10/28/2021 Christian Covenant Church W Hamlin Rd, Rochester Hills, MI

Site Plan Review Reviewed for compliance to the City Ordinance, Building and Fire Codes				
Department Planning	Kristen Kapelanski 248-841-2772 KapelanskiK@RochesterHills.org	Approved Yes		
Building	Mark Artinian 248-841-2446 ArtinianM@RochesterHills.org	Yes		
Engineering	Jason Boughton 248-841-2490 BoughtonJ@RochesterHills.org	Yes		
Traffic	Keith Depp 248-841-2503 DeppK@RochesterHills.org	Yes		
Nat. Resources	Matt Einheuser 248-841-2551 EinheuserM@RochesterHills.org	Yes		
Fire	Lt. Josh Boyce 248-841-2713 BoyceJ@RochesterHills.org	Yes		
City of Rochester Hills Planning & Economic Development				
Conditions and mark-ups noted throughout the plan set must be addressed prior to final approval.

900 W. Hamlin Rd - Cover Sheet

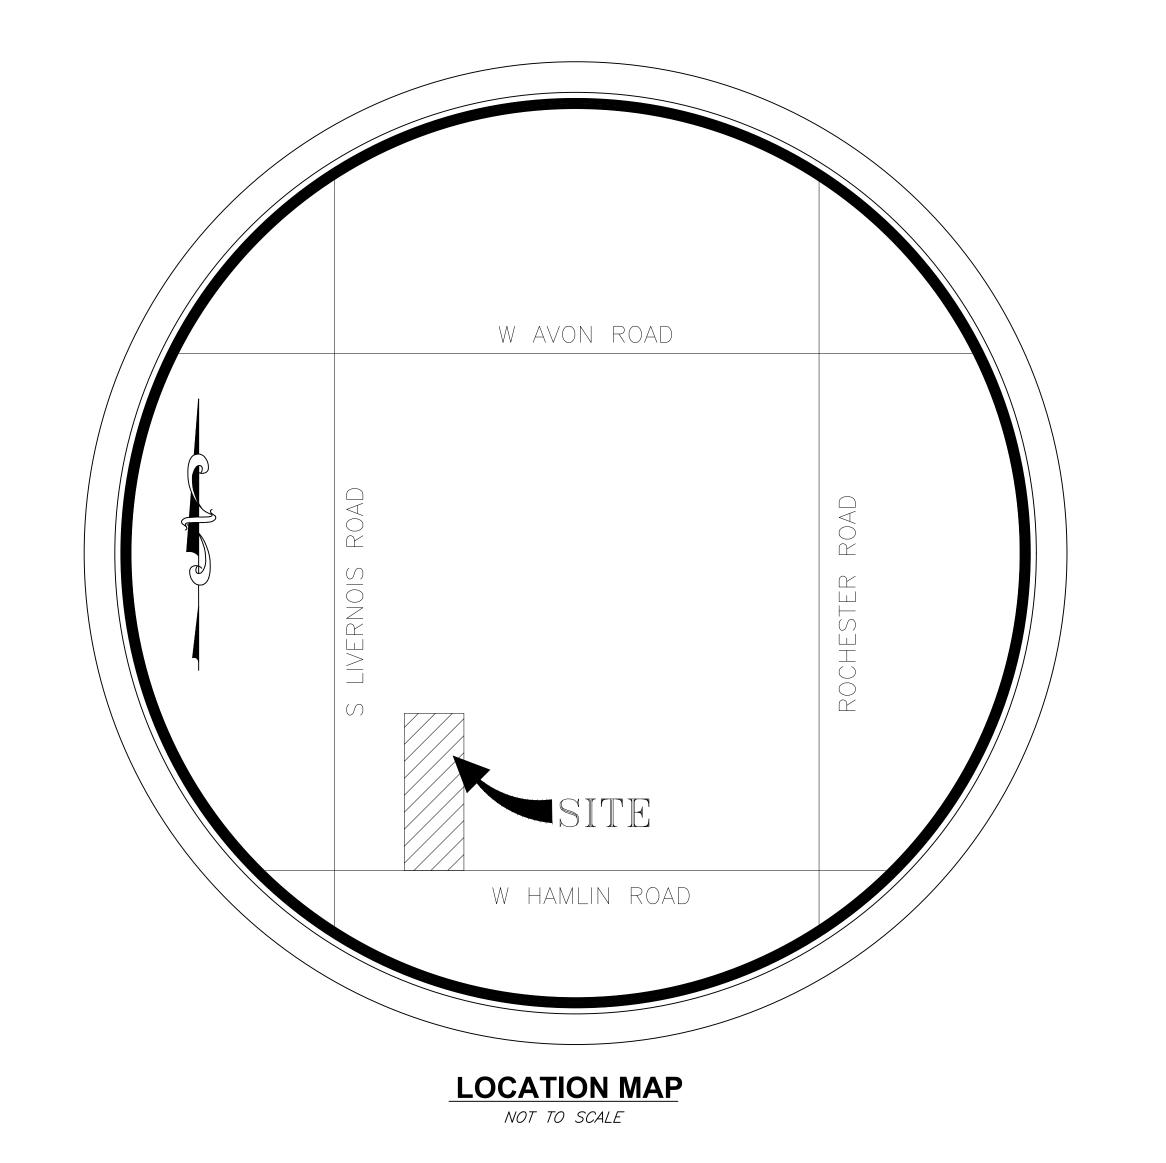
A conditional use permit is required for the proposed drive-through. Refer to Section 138-1.203 of the Zoning Ordinance for required signage that must be placed on the property 15 calendar days prior to the public hearing.

The applicant needs to submit a Land Improvement Permit (LIP) application with engineer's estimate, fee and construction plans to proceed with the construction plan review process
